AFFIDAVIT

This document is made and executed this 14th day of November, 2001, to inform concerned persons of a correction to the plat of the Lantern Hill at Willow Creek, a planned unit development, recorded as Entry No. 7452930 in Book 99-8P at Page 248. The corrections to the plat are as follows:

Items 1-3:

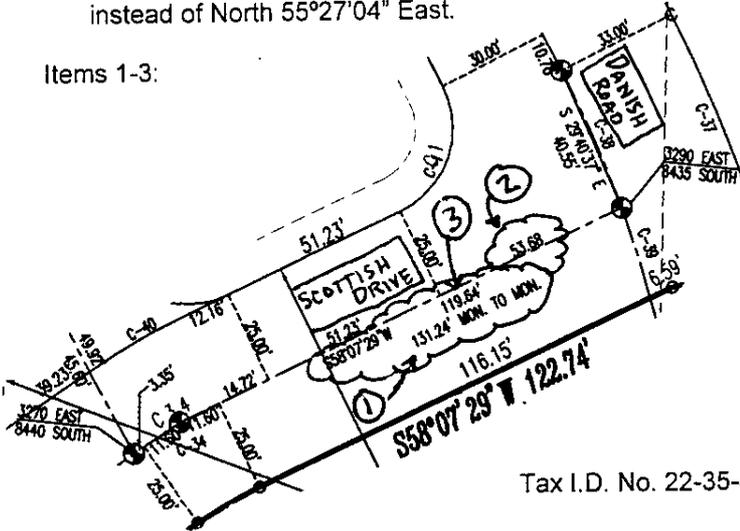
1. The distance between the monuments at the intersection of Danish Road and Scottish Drive to the next point of intersection monument at a bearing of South 58°07'29" West is 131.24 feet instead of 133.75 feet.

2. The intermediate distance between said monument at the intersection of Danish Road and Scottish Drive to the point of reverence to the point of curvature of Lot 1 is 53.68 feet instead of 56.19 feet.

3. The intermediate distance between said monuments at the intersection of Danish Road and Scottish Drive to the point of reference of the point of curvature on the south boundary line of said Lantern Hill at Willow Creek P.U.D. is 119.64 feet instead of 122.15 feet.

Item 4:

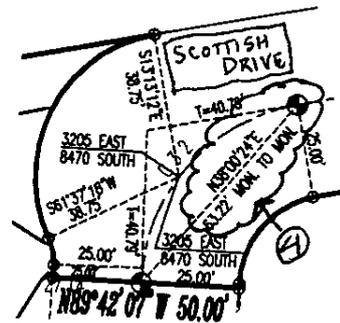
4. The bearing between the two most southwesterly monuments on Scottish Drive is North 38°00'24" East instead of North 55°27'04" East.
